Shellmound Way General Plan Amendment Concerns

City Council and Bike/Ped Committee Members-

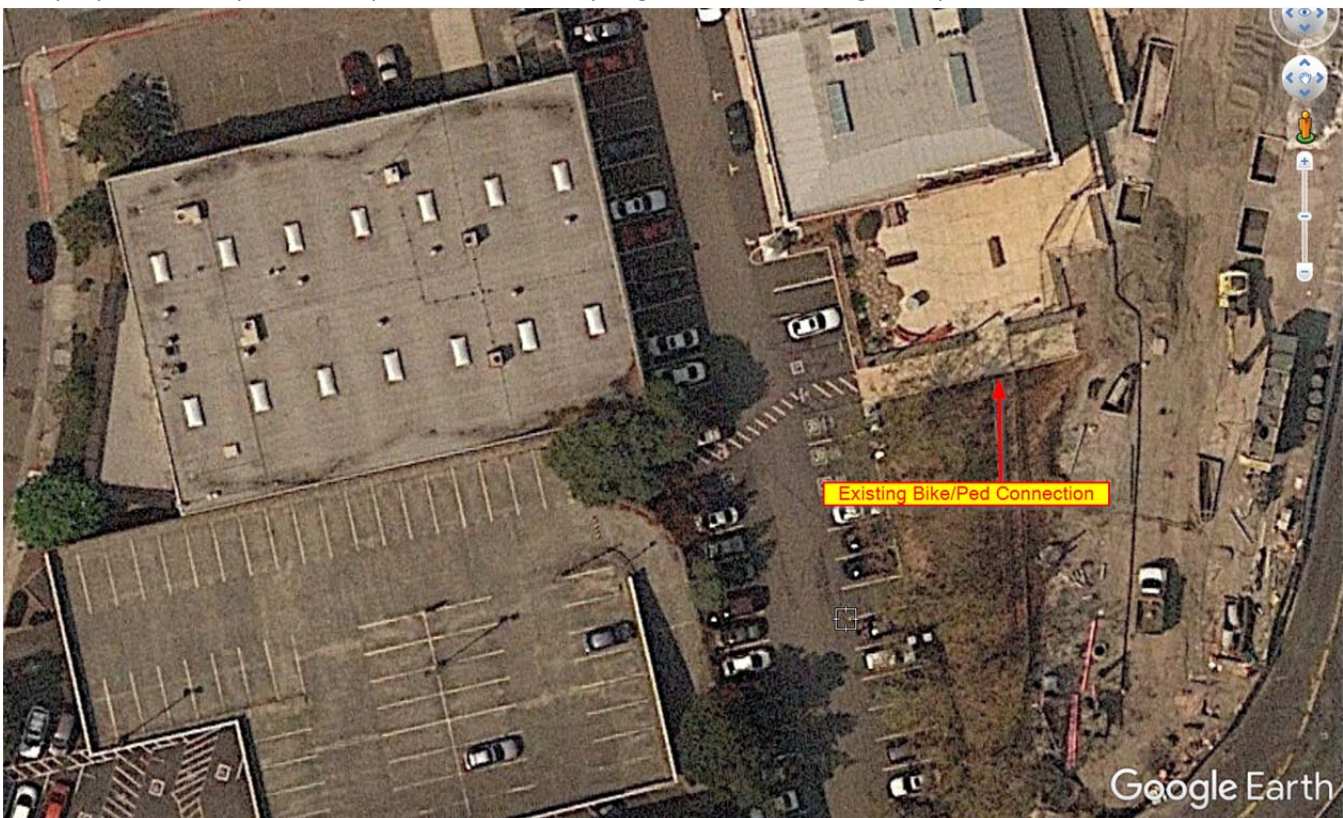
The path that I'm proposing would create a block that is approximately 200' long – the typical length of a city block in downtown Portland.

The proposed bike/pedestrian path would directly align with the existing bike/ped connection at the Public Market.
